Macquarie Park Precinct and Bus Interchange upgrade

Submissions Report
December 2022

Figure 3-1: Location of existing and proposed Macquarie Centre exits

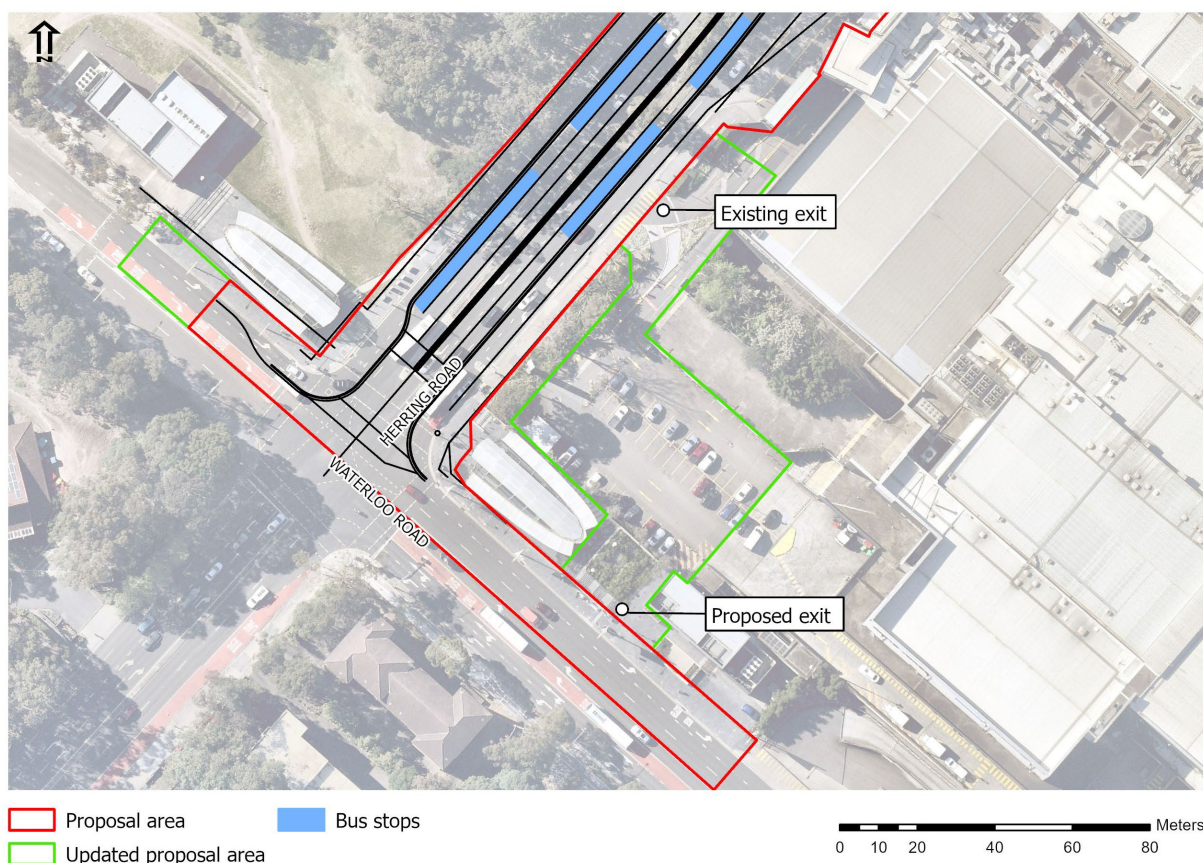
Transport is proposing to relocate the existing Macquarie Centre exit, located about 60 metres north of the Herring Road / Waterloo Road intersection, to a new location on Waterloo Road. The location of the existing exit and proposed exit is shown in Figure 3-1.

While the future redevelopment of Macquarie Centre would remove the need for the existing exit, the timing of that redevelopment means a temporary solution is required to address the following issues at Herring Road:

- conflict point between customers accessing the Metro, Macquarie Centre and Macquarie University, bus stands and exiting vehicles
- drivers exiting onto Herring Road from Macquarie Centre have limited views of approaching traffic due to the driveway gradient and vegetation
- proposed plaza space has increased adjacent to Herring Road southbound which in turn would increase conflict zone with pedestrians
- potential interference with bus interchange operations
- potential for driver confusion regarding traffic arrangements on Herring Road and need for a change to traffic lights to accommodate general traffic on this section of Herring Road.

Figure 3-2: Proposed exit to Waterloo Road

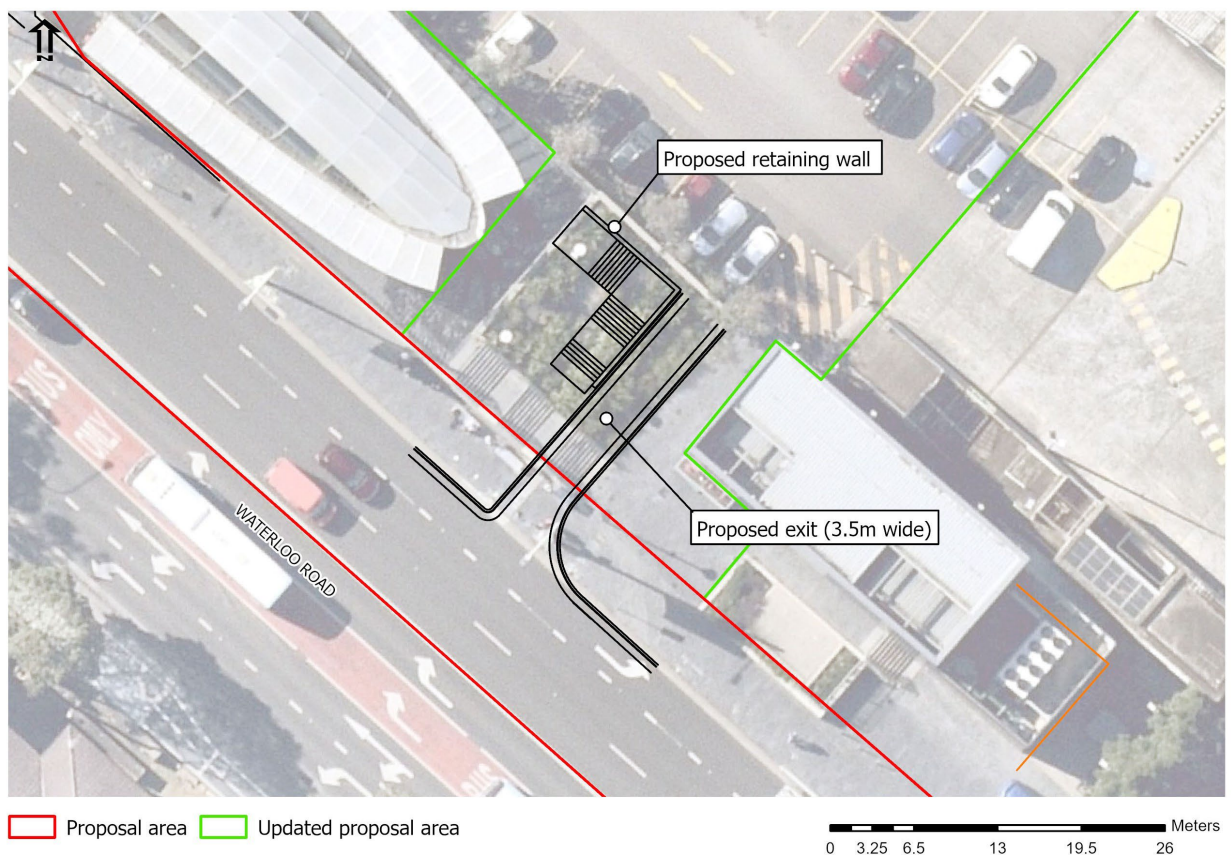
The proposed change involves the following (refer also to Figure 3-2):

- reconfiguration of the staircase and retaining walls to allow for the exit
- relocation of bus stop (2113318) a short distance to the west on Waterloo Road
- removal of landscape vegetation and up to four trees within the existing car park
- relocation or removal of street lighting (one pole), lighting within the landscaped area (two poles) and street furniture (including bins)
- protection and/or adjustment of utilities
- civil works associated with the closure of the existing exit on Herring Road.

While the existing car park is shown within the updated proposal area, this car park would remain operational during works with any temporary impacts on vehicle movements or parking capacity to be addressed in consultation with AMP Capital (Macquarie Centre).

Figure 3-3: Kiss and ride locations

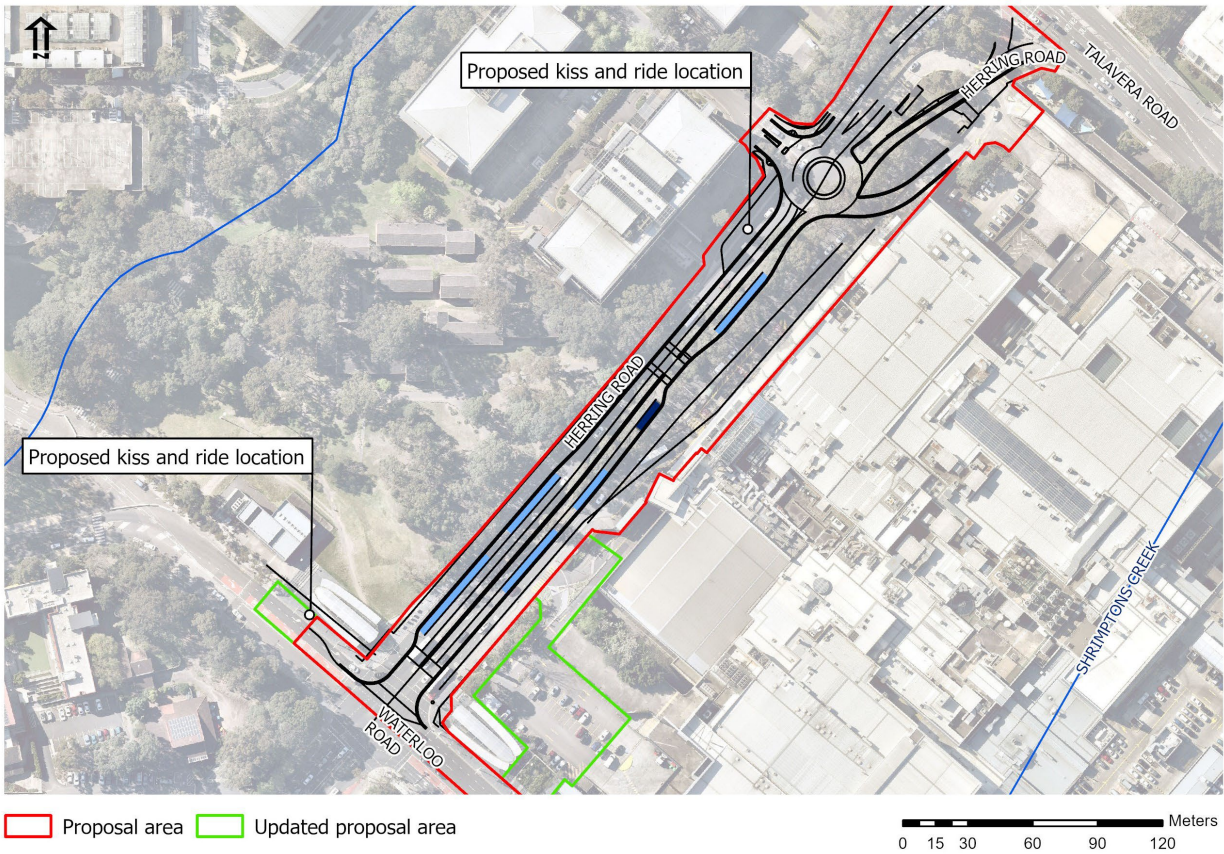
Transport is proposing to relocate the kiss and ride zone (one space) on Herring Road south of the mid-block pedestrian crossing to Herring Road near Innovation Road and /or University Avenue. Works would be limited to the provision of signage at these locations.
